SINGLE SIDEBAND
RADIO COMMUNICATIONS EQUIPMENT

TYPE - SSB-1

ADDENDUM No. 2.

TEMPORARY CORRECTION T-1 TO THE TECHNICAL MANUAL FOR TYPE SSB-1 SINGLE-SIDEBAND RADIO COMMUNICATION EQUIPMENT (NAVSHIPS 92917).

FIGURE 2

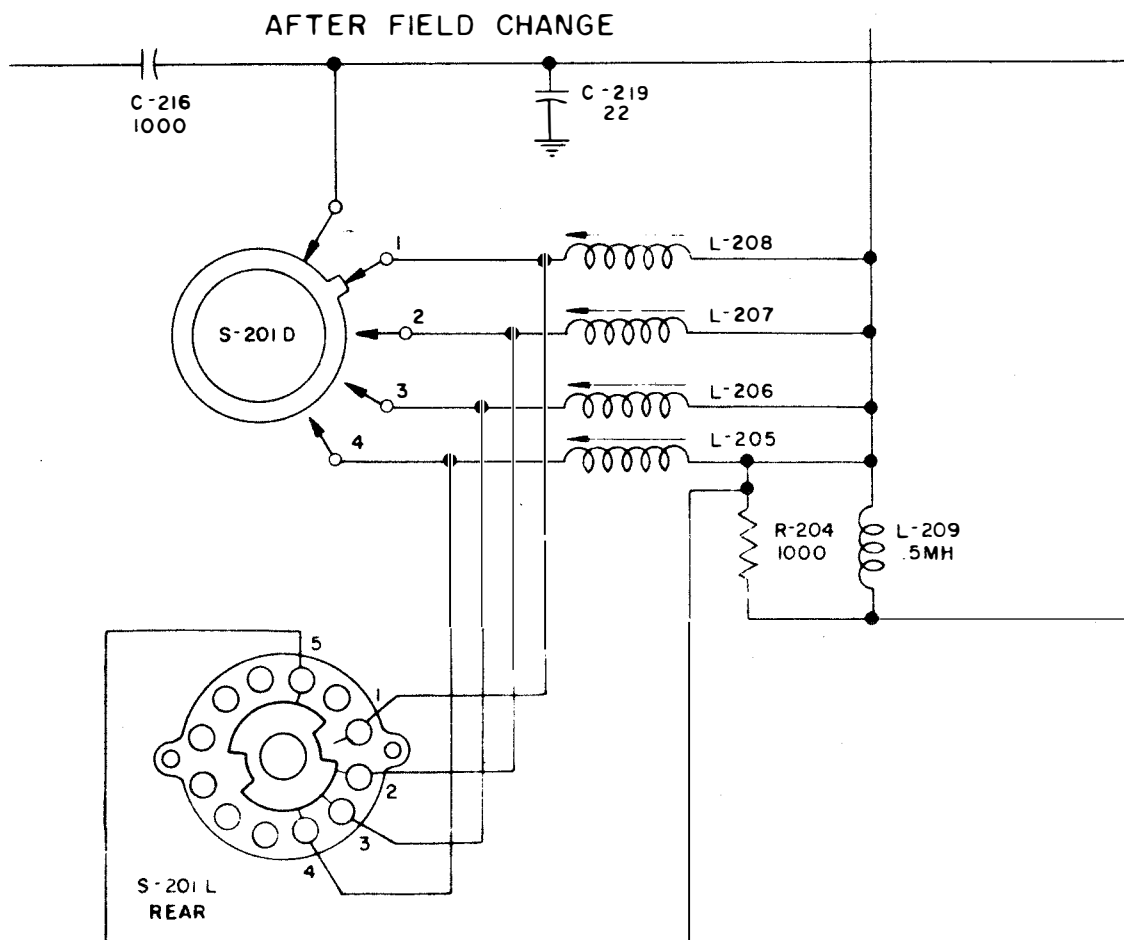
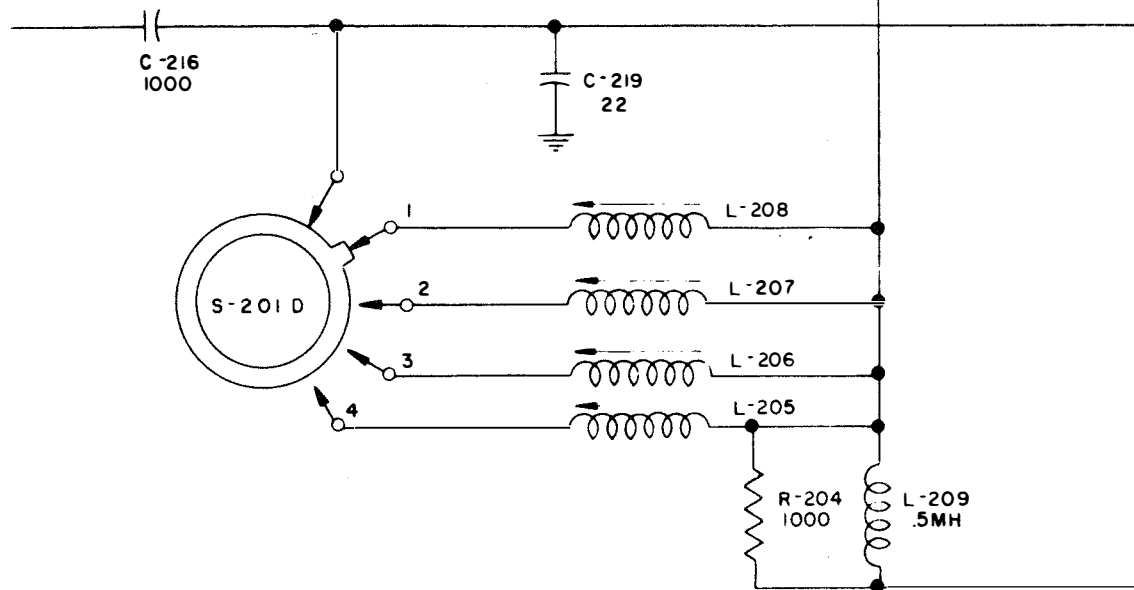
1. Transmitter-Receiver Schematic, Pages 75, 76, 77 and 78; Figures 29 and 29B.

Referring to temporary correction Figures 1 and 2, make the necessary pen-and-ink correction to the Transmitter-Receiver Schematics to conform with Field Change 6-SSB-1.
